KANEPACKAGE PHILIPPINE INC.

INVESTIGATION REPORT FORM (IRF)

Customer	MERASENKO CORP.	Attention To	WEENA APALLA
Item Code	473MB-RMFG	Department	PRODUCTION
Item Description	OXYGEN TUBE 260X180X42.5; A	Date of Detection	240614
Job Order Number	JO24-C-00130-13A	Section Detected	QA SCREENING

ILLUSTRATION OF THE PROBLEM

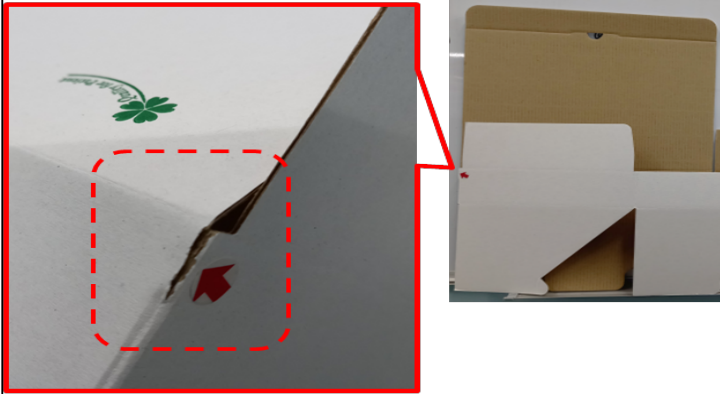
ACTUAL: With bursting up to 15mm
REQUIREMENT: Bursting up to 10mm acceptable

Lot Quantity (pcs)	Reject Qty (pcs)	Reject %
1000	29	2.90
Nature of Defect:		
BURSTING		
Requirement:		
With bursting up to 15mm		
Actual		
Bursting up to 10mm is acceptable

WHY 1 : W1 Items process in S1700 and without application of creasing matrix in this condition it is impossible to have bursting at the outer portion or white kraft. r n r nW2 The factor we consider is tear off due to slanting of item in SD1800 feeder. r n r nW3 Based on interview in SD1800 operator they encounter tear off including in this item if there is slanting of item in SD1800 feeder. r n r nW4 Since this item have only 45.5mm height dimension and 913mm length it become prone to tear off when got slanted in SD1800 feeder.

WHY 1: Conduct study in SD1800 on how to improve the occurrence of slanting of items in feeder area of SD1800 then give update to QA for the Corrective Action
